Access Compliance Report

Public Rights-of-Way

Intersection ID: 51044	Main Street: KENDALL_DR	Cross Street: LONGNOR_ST	Location: NW
ADA ID: 95DA5D29942A	Ramp Type: PerpDiag	Initial Pass/Fail: Fail	Overall Compliance: No
		Severity Score: 12.5

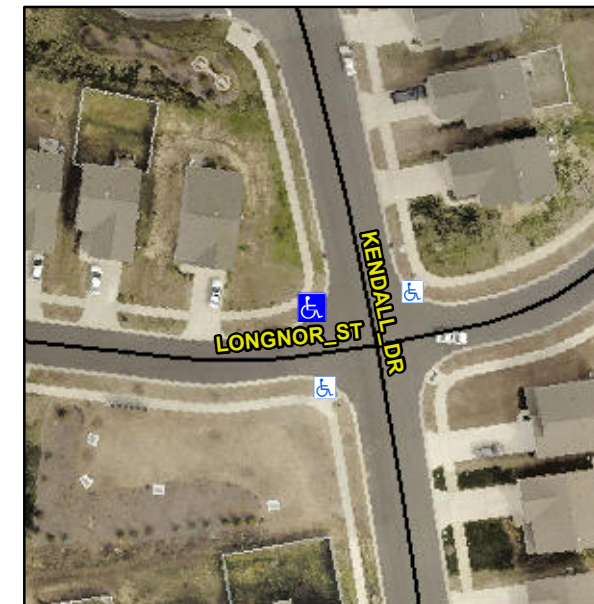
Not Found, R304.5.3

Compliance	Description	Data	Compliance	Description	Data
N/A	Ramp Length (in)	73.0	Yes	Ramp Slope (%)	5.5
Yes	Ramp Width (in)	60.0	No	Ramp XSlope (%)	5.1
N/A	Flare Type LT	N/A	N/A	Flare Type RT	N/A
N/A	Flare Slope LT (%)	N/A	N/A	Flare Slope RT (%)	N/A
N/A	Flare Traversable LT?	N/A	N/A	Flare Traversable RT?	N/A
N/A	Landing Length (in)	N/A	N/A	DWS Provided?	N/A
N/A	Landing Width (in)	N/A	N/A	DWS Contrast?	N/A
N/A	Landing Slope (%)	N/A	N/A	DWS Length (in)	N/A
N/A	Landing X Slope (%)	N/A	N/A	DWS Full Width?	N/A
N/A	Landing Curb? (Y/N)	N/A	N/A	DWS Offset (in)	N/A
N/A	Shared Landing?	N/A			
N/A	Gutter Ponding?	N/A	N/A	Gutter Slope (%)	N/A
N/A	Gutter Lip Ht (in)	N/A	N/A	Gutter X Slope (%)	N/A
N/A	Painted X Walk1?	No	N/A	Painted X Walk2?	No
	X Walk 1 Direction	To S		X Walk 2 Direction	To E
N/A	X Walk 1 Width (in)	N/A	N/A	X Walk 2 Width (in)	N/A
	X Walk 1 Slope (%)	1.2		X Walk 2 Slope (%)	8.2
	X Walk 1 X Slope (%)	5.7		X Walk 2 X Slope (%)	4.8

Remove & Replace Curb Ramp With Two New Directional Ramps or Equivalent.
